# CITY PLAN COMMISSION STAFF REPORT

**47 Madison**

CD-CPC-2021-00203  
Development Plan - Major Amendment

## Plan Conditions, Corrections, & Recommendations Report

LANDSCAPE PLAN

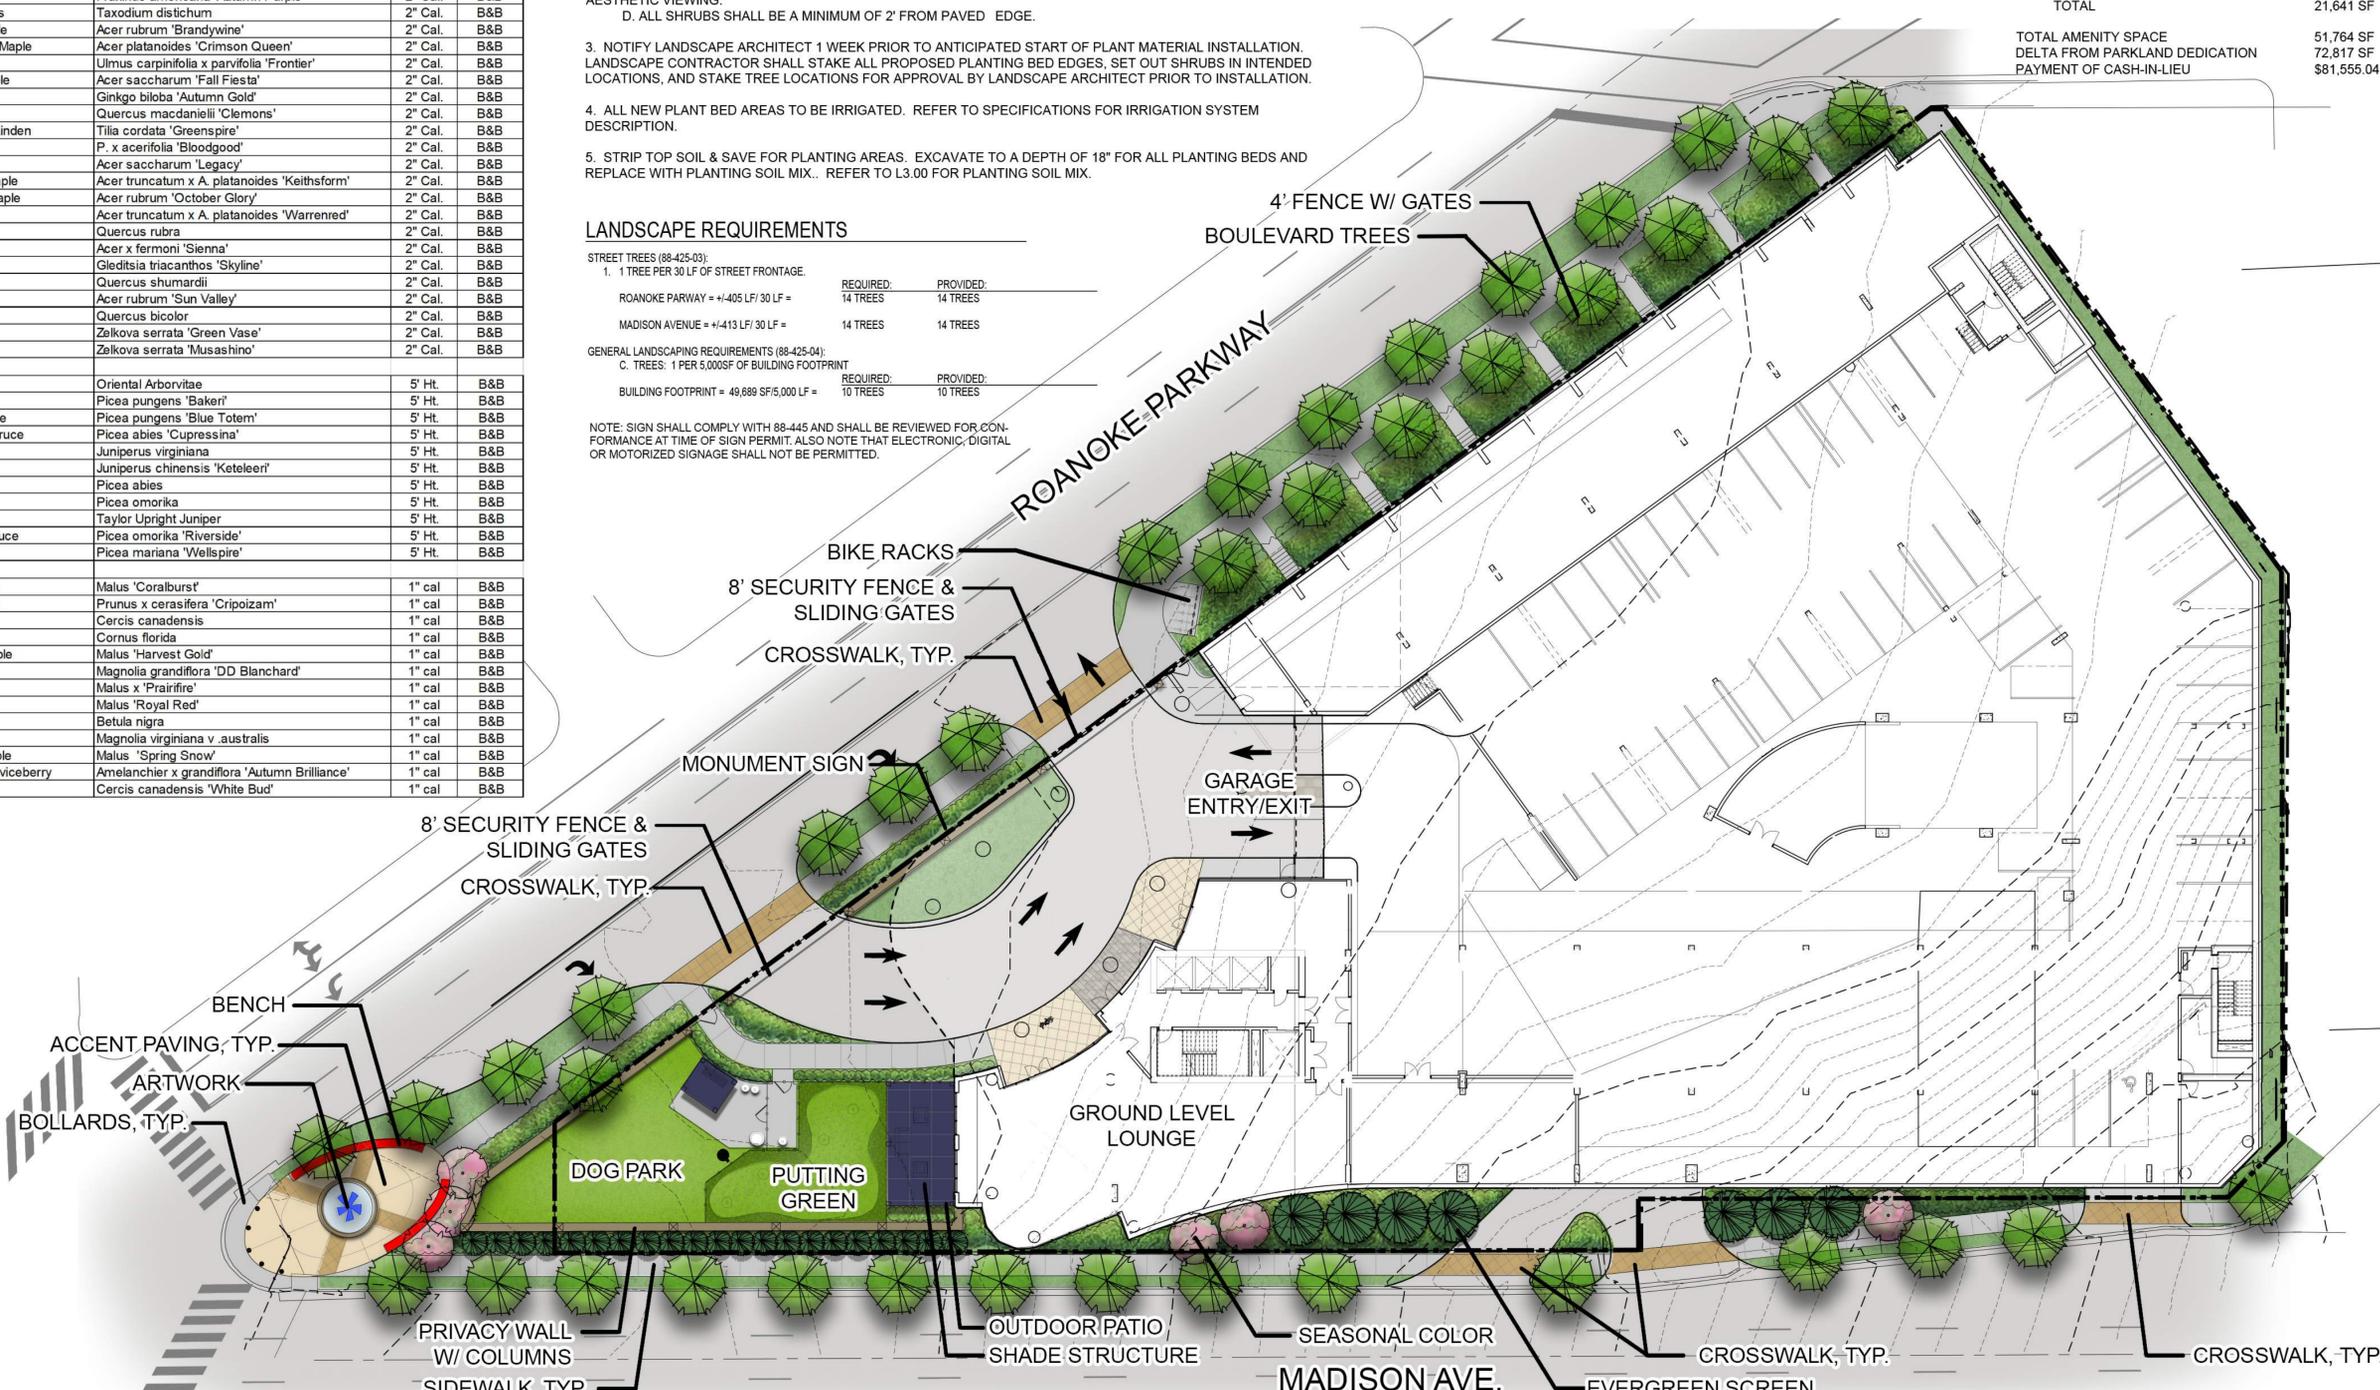
31. The developer shall submit a streetscape plan with street tree planting plan per 88-425-03 for approval and permitting by the Parks & Recreation Department's Forestry Division prior to beginning work in the public right-of-way (12/01/2021)

**PHOTOMETRIC PLAN**  
SCALE: 1" = 20'-0"

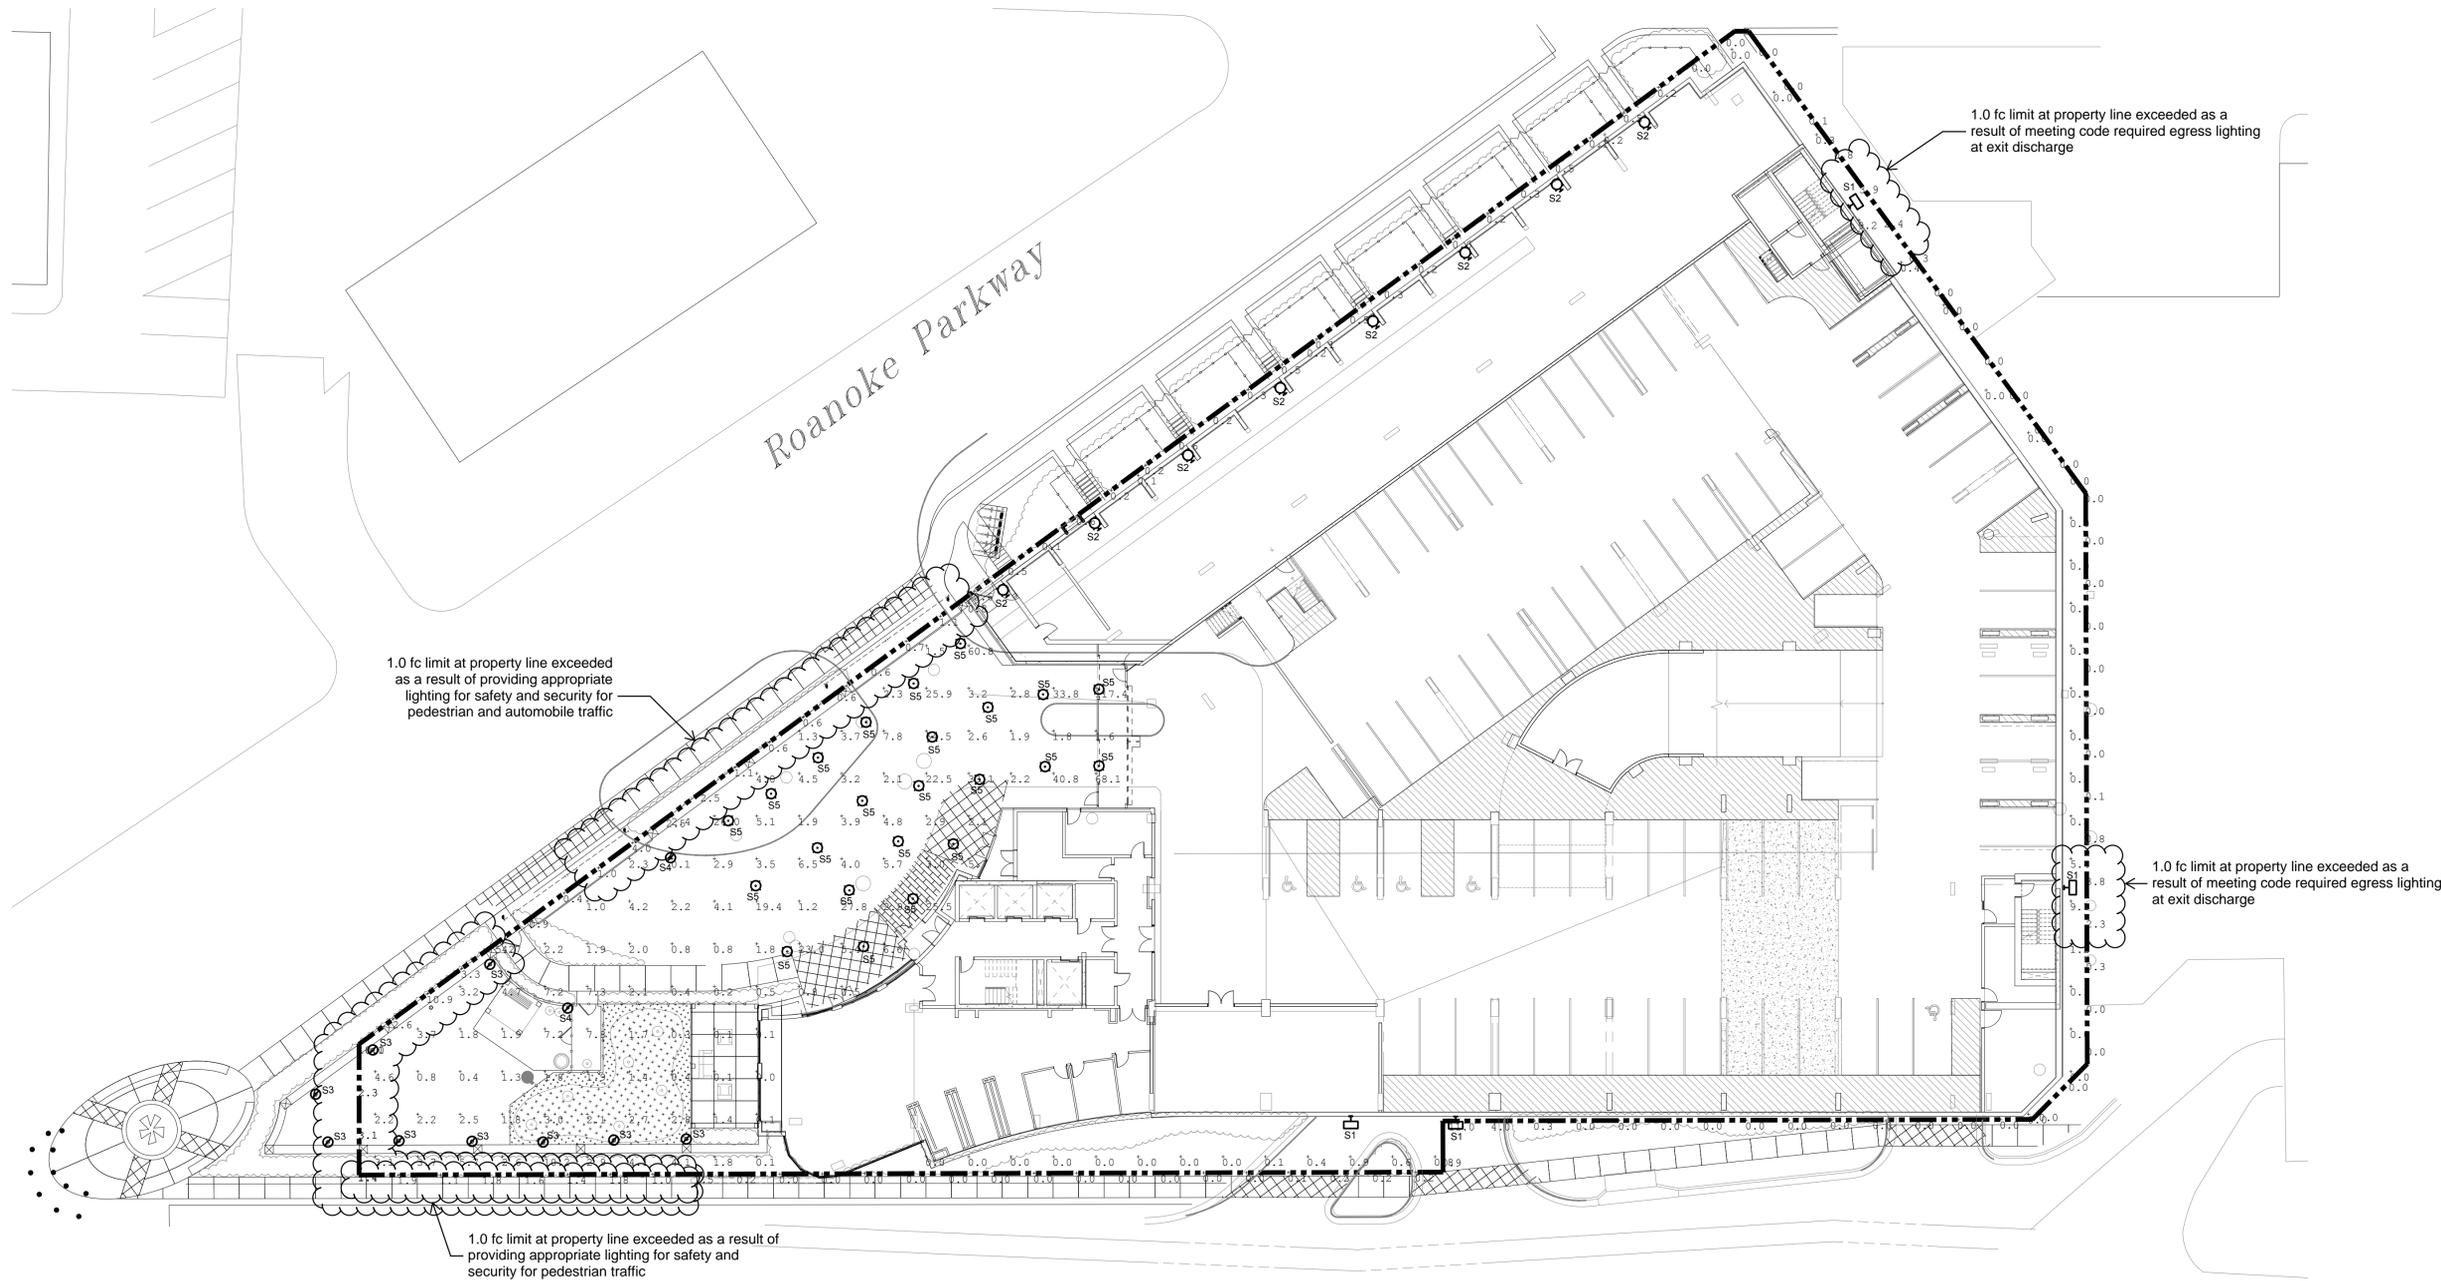
The photometric plan should also show spillover light effects on the adjacent properties and public rights-of-way.
